TRACT MAP NO. 73336

TENTATIVE MAP DATED <u>06/15/16</u> EXHIBIT MAP <u>06/15/16</u>

MAJOR SUBDIVISION **VESTING TENTATIVE** TRACT NO. 073336

GRADING

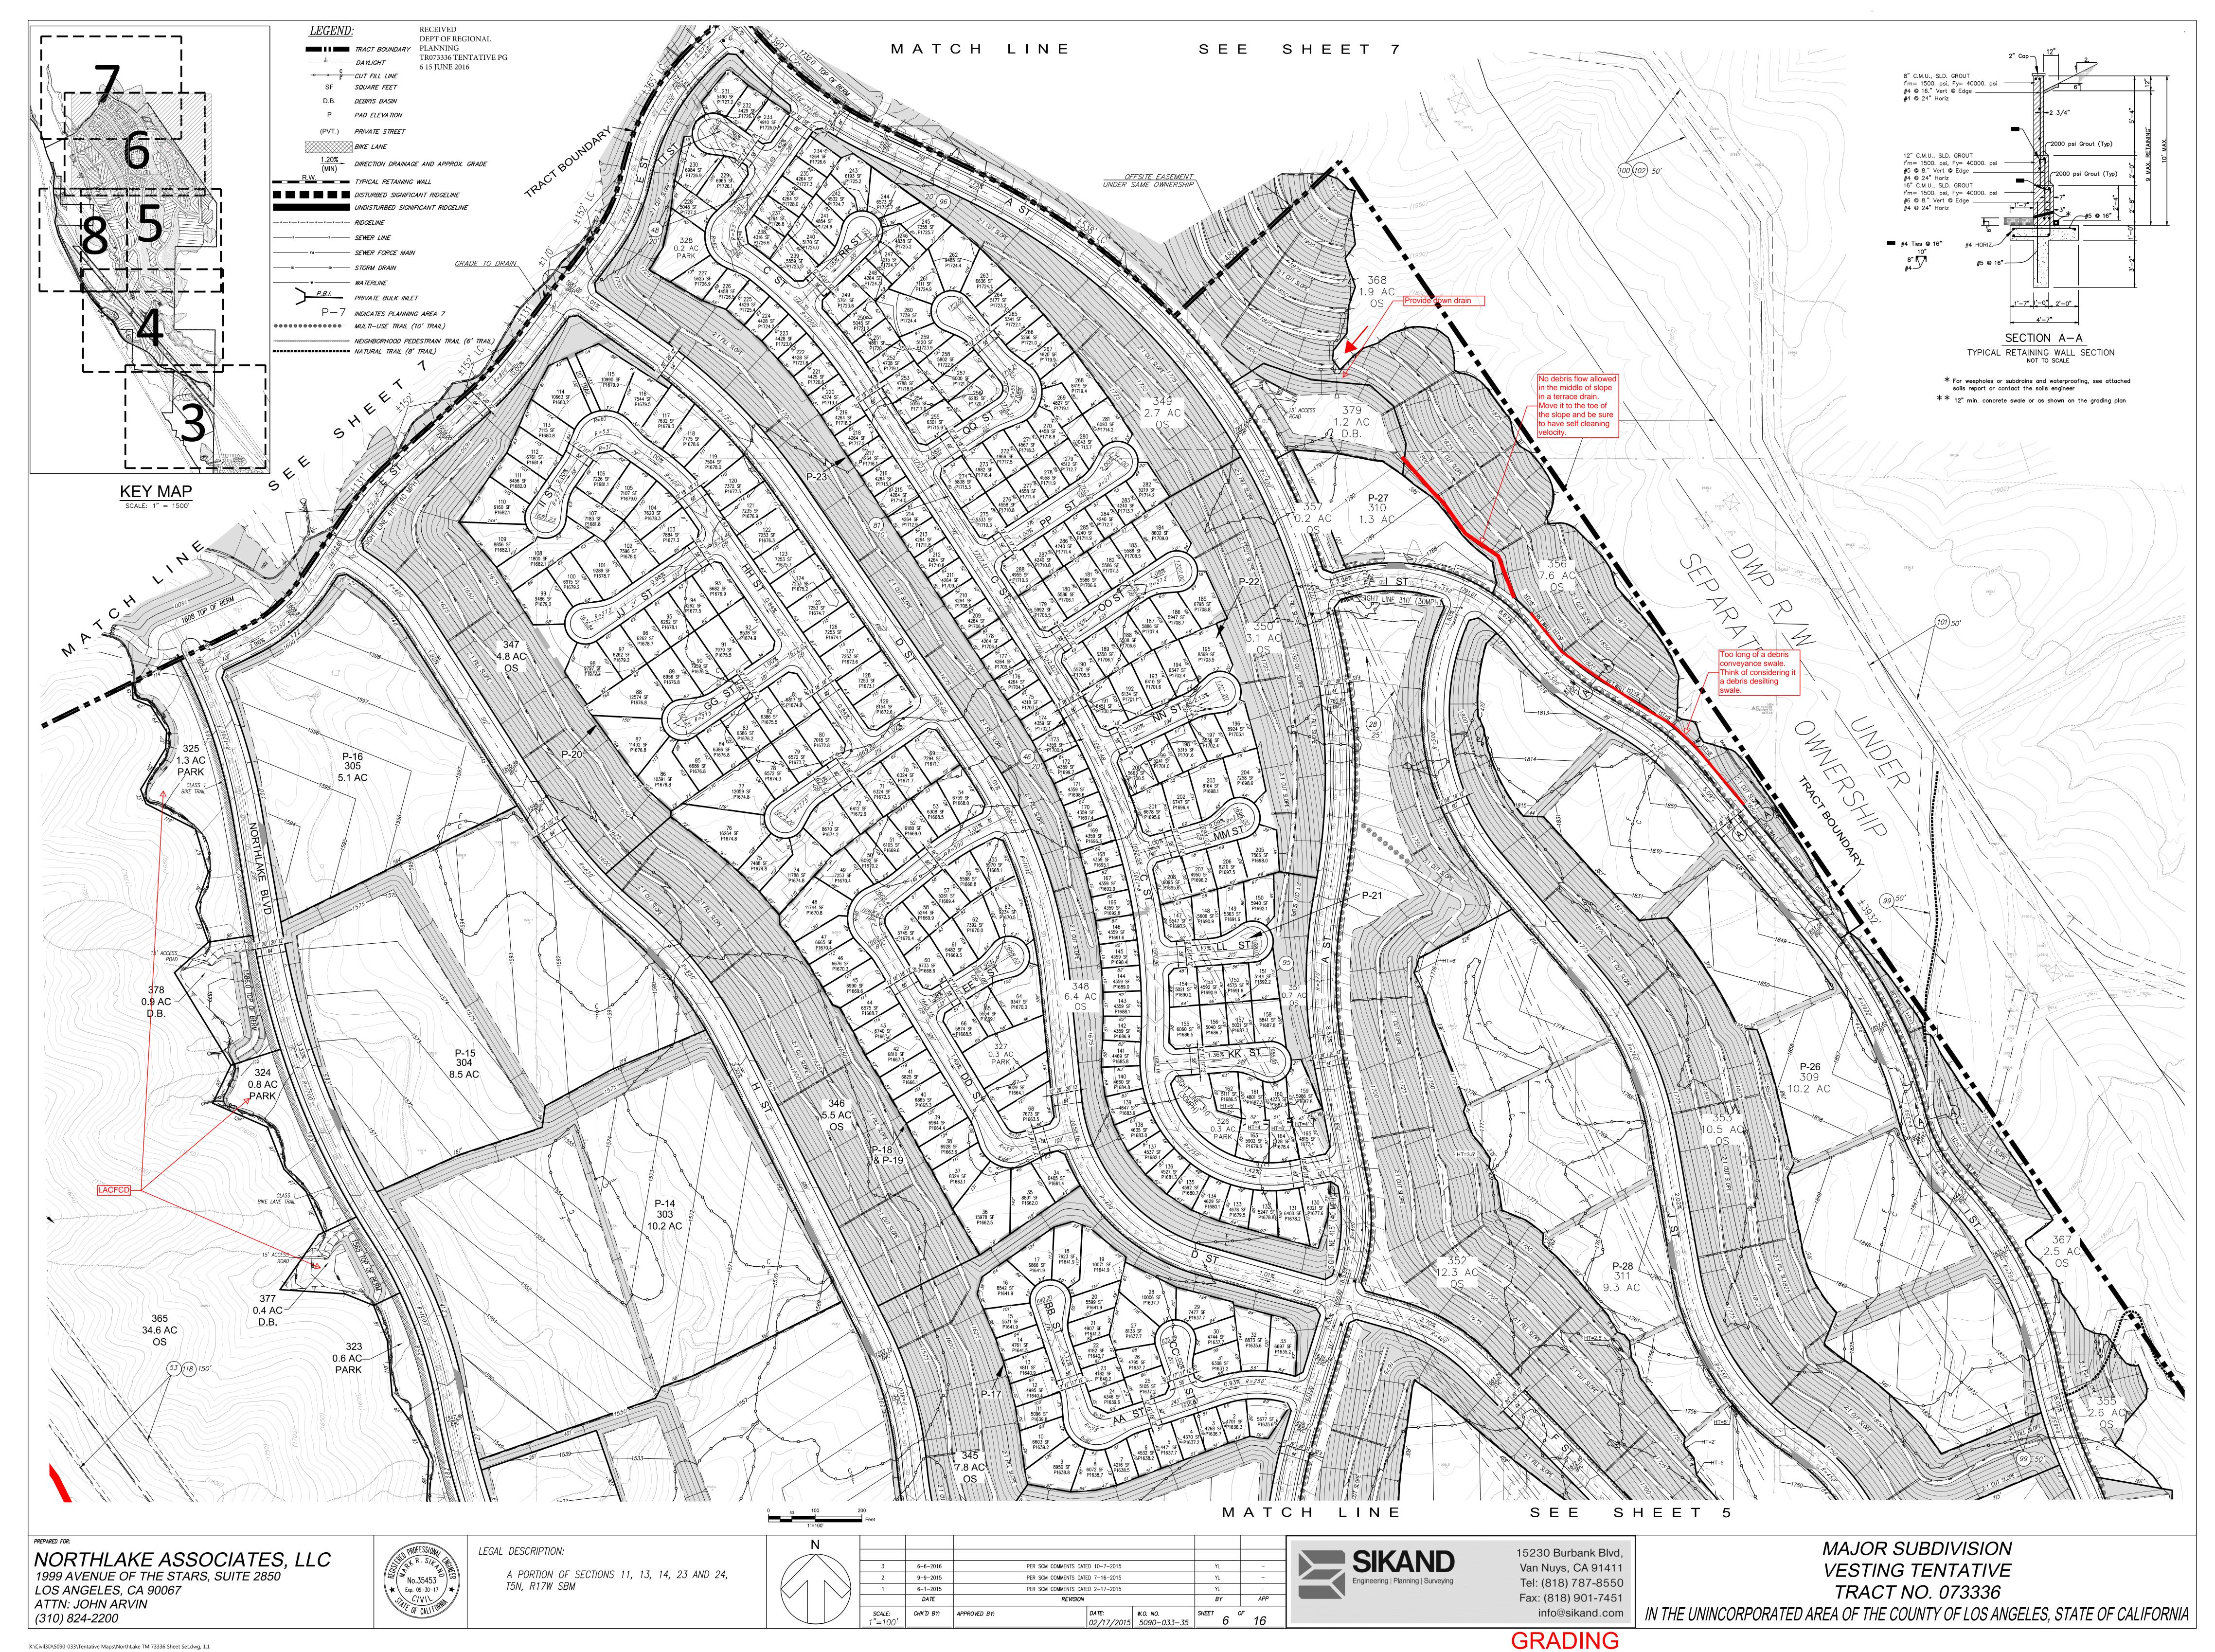
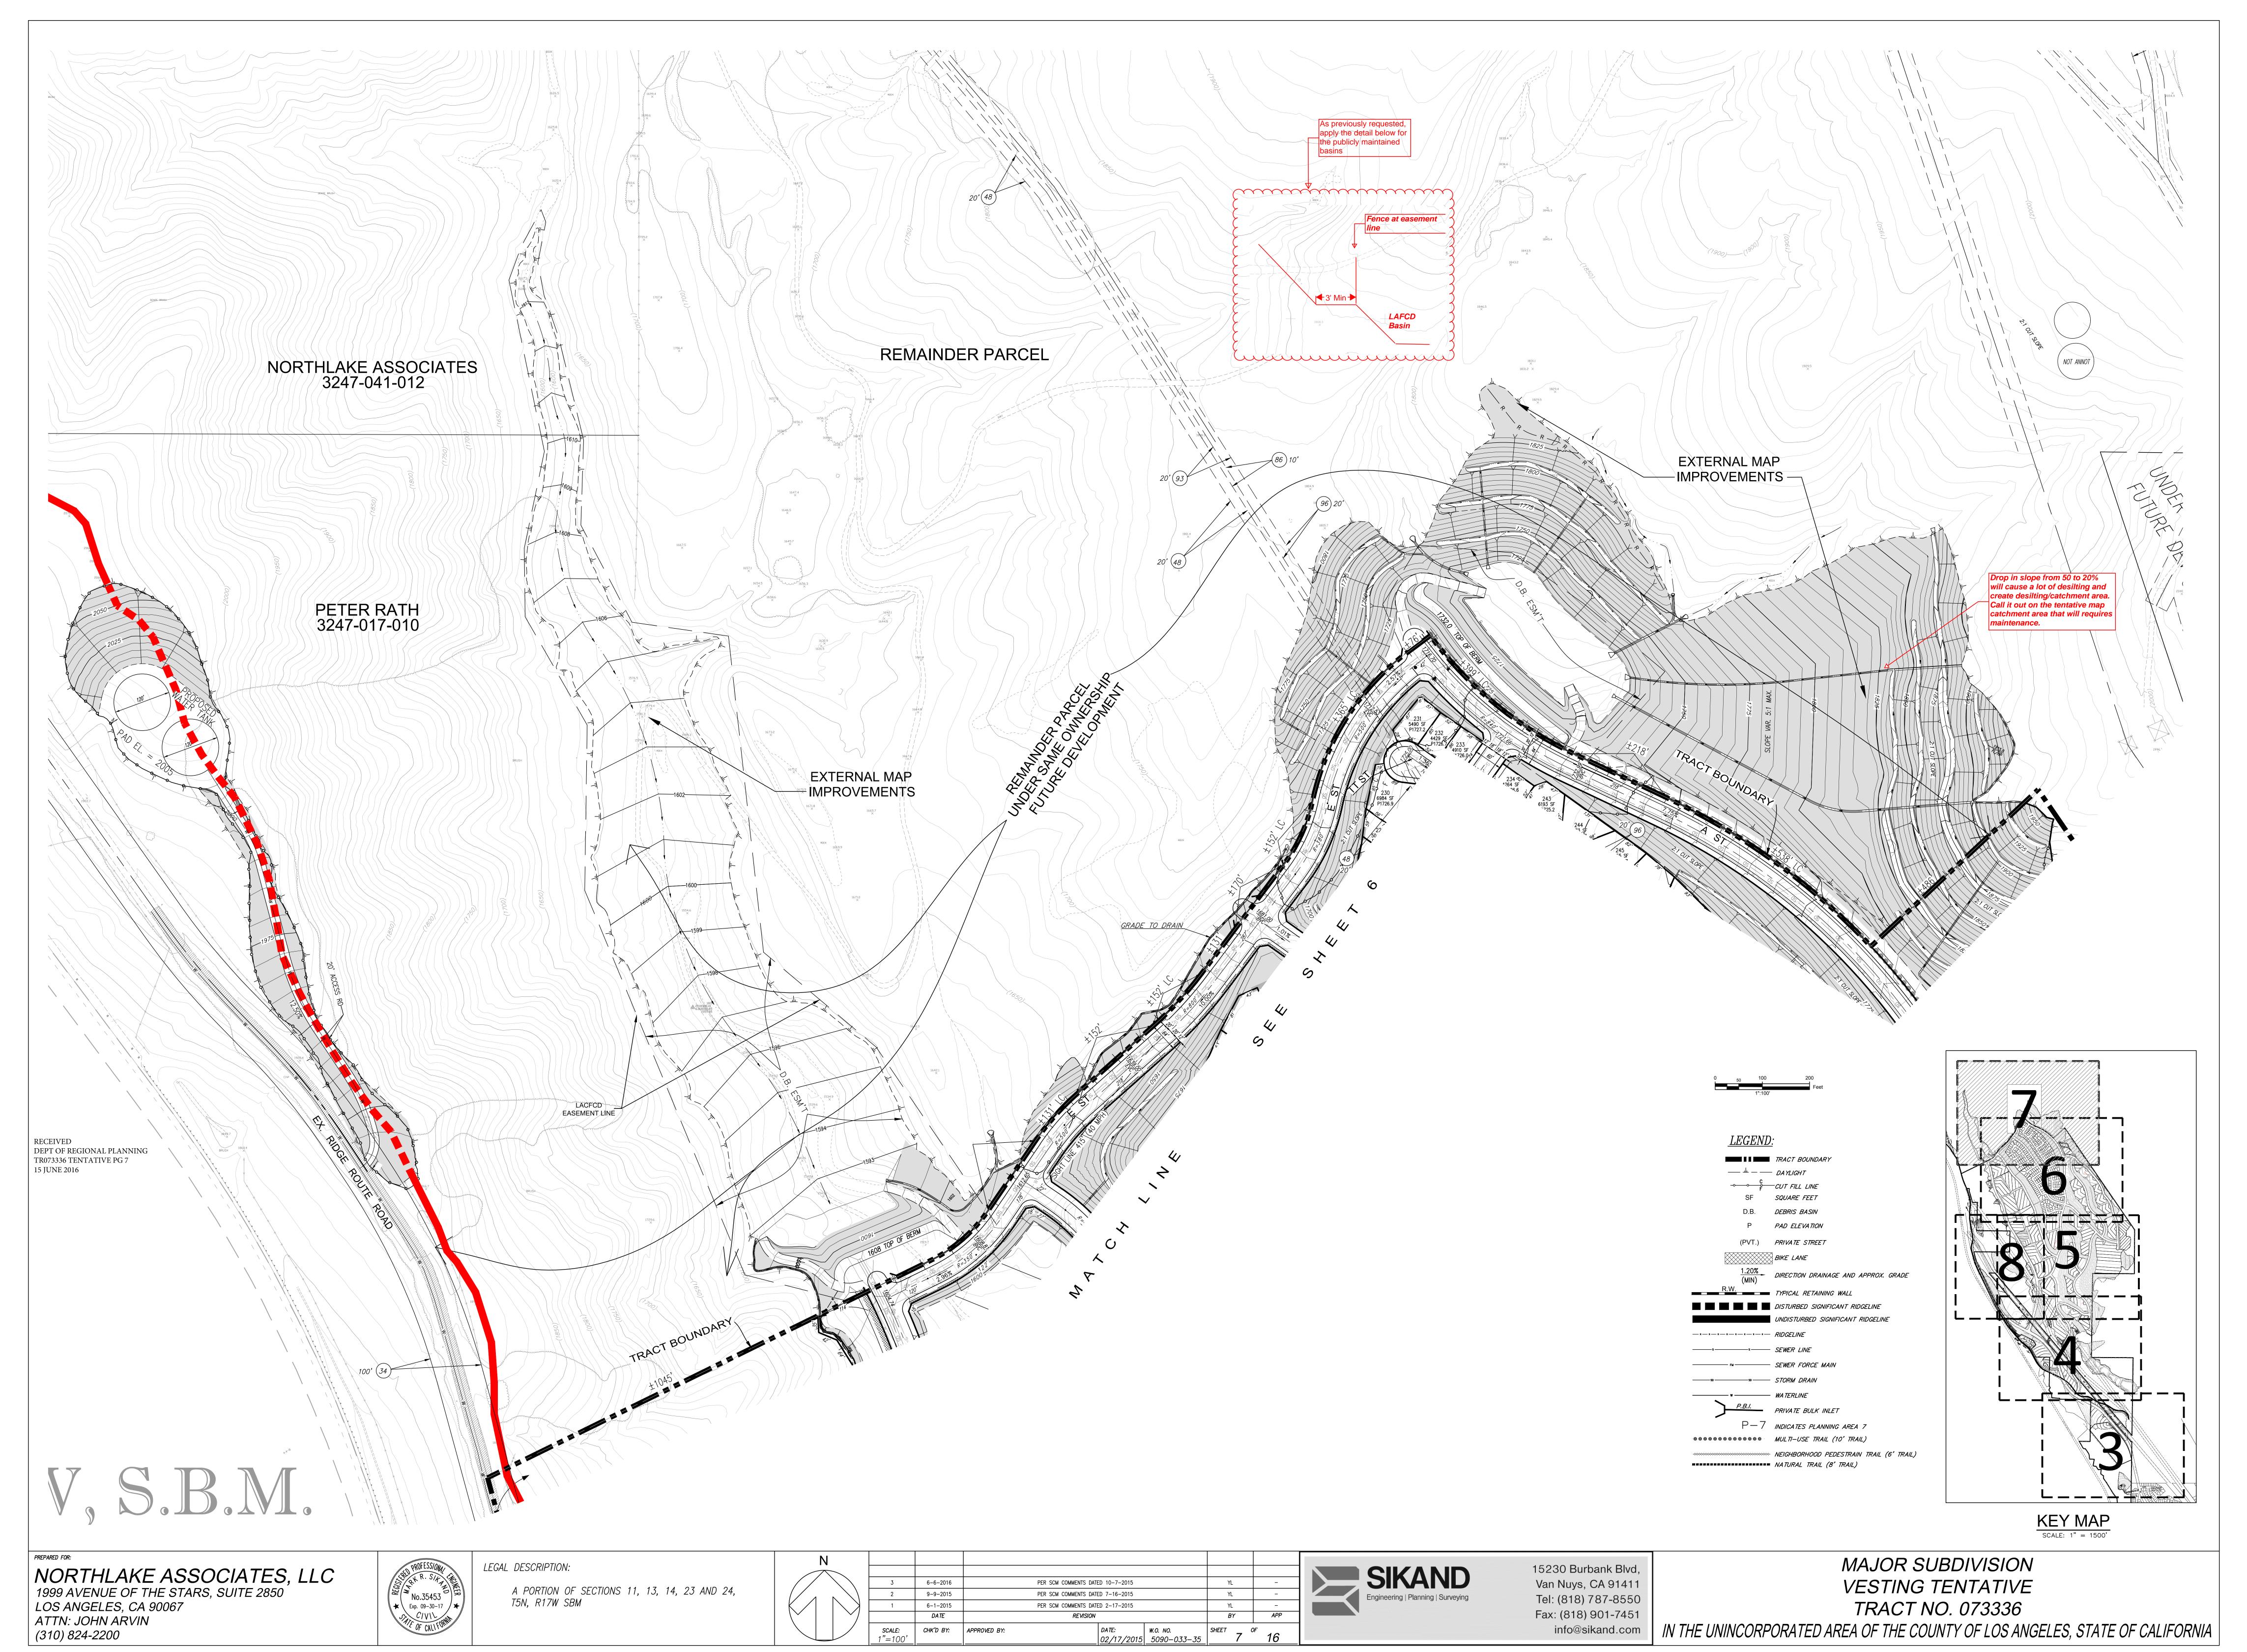
- 1. A revised tentative map is required to show the following additional previously requested items:
 - a. Curb face height for the private driveway and fire lane.

- b. Catchment areas and devices that expected to receive desilted debris and required periodic maintenance. These areas and devices must be accessible.

- c. More contour line elevations
 - d. Identify the maintenance responsibility (Public or Private) of all basins.
 - e. Drainage device at tow of slopes 5' or higher adjoining right of way of a section with sidewalks at right of way lines to avoid runoff or irrigation flow to the sidewalks.

- 2. Approval of the latest drainage concept/hydrology study/water quality plan by the Storm Drain and Hydrology Section of Land Development Division.
- 3. Emergency overflow of debris basin 371 and 380 are not properly designed. The adjoining improvements may be flooded.

- 4. Provide minimum 3 feet wide terrace on top and outside the easement limit or fee lot lines of all publicly maintained basins to separate slopes to be maintained within the basin from the slope to be privately maintained outside the basin.

- 5. Additional Comments in red on the attached tentative map.
